ADDENDUM #1

Date: May 6, 2021

DPW 21609 IDVS: WALL PROTECTORS/GUARDS, VET-P POCATELLO, ID NBW#21004

MAIN LEVEL PART 4

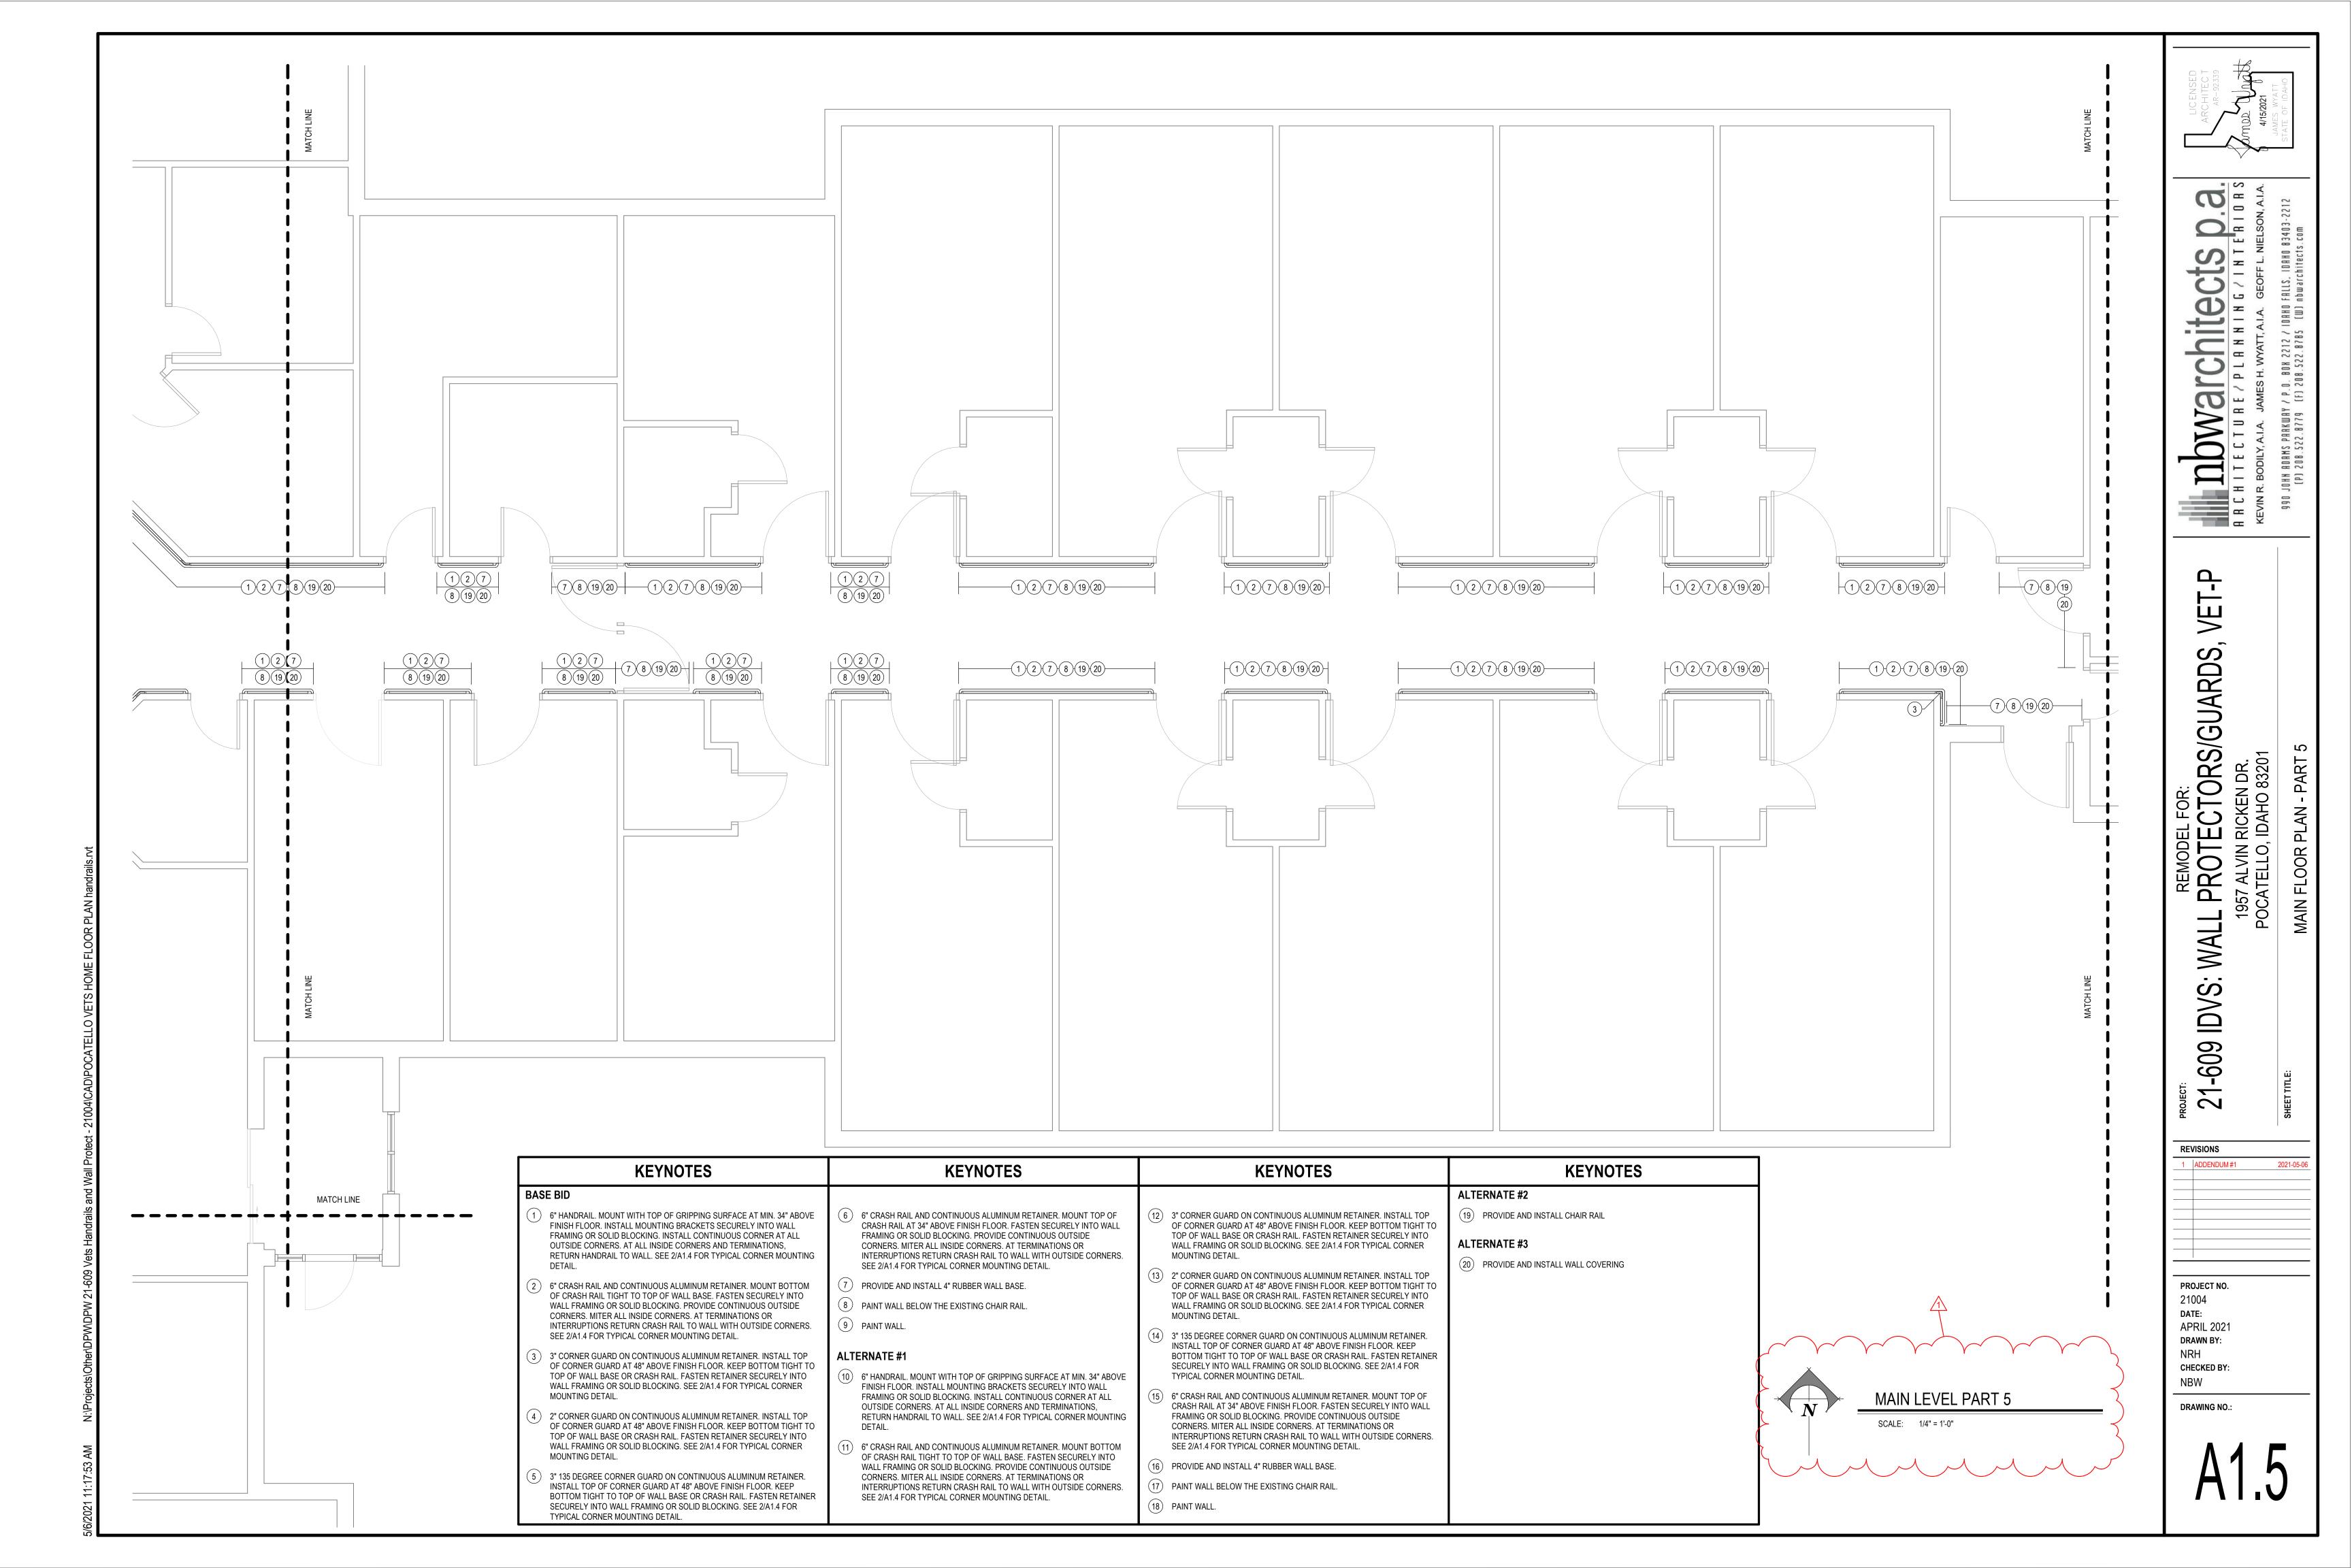
- 1. Sheet A1.3
 - a. See attached revised sheet.
- 2. Sheet A1.4
 - a. See attached revised sheet.
- 3. Sheet A1.5
 - a. See attached revised sheet.

TYPICAL CORRIDOR CONDITION

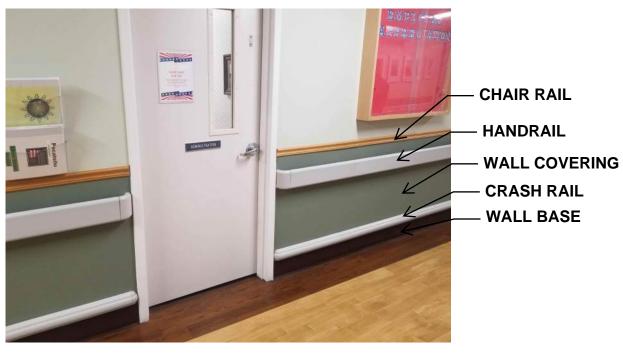
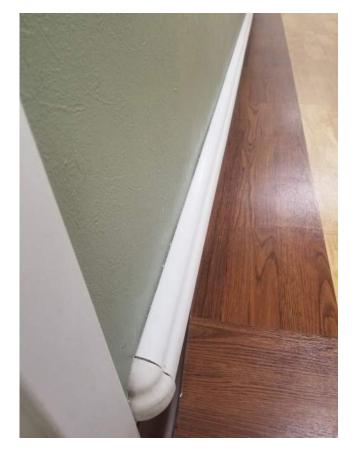
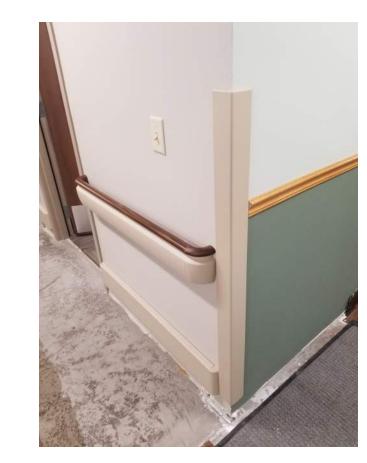
1. Attached is a sheet of photos depicting the typical existing conditions.
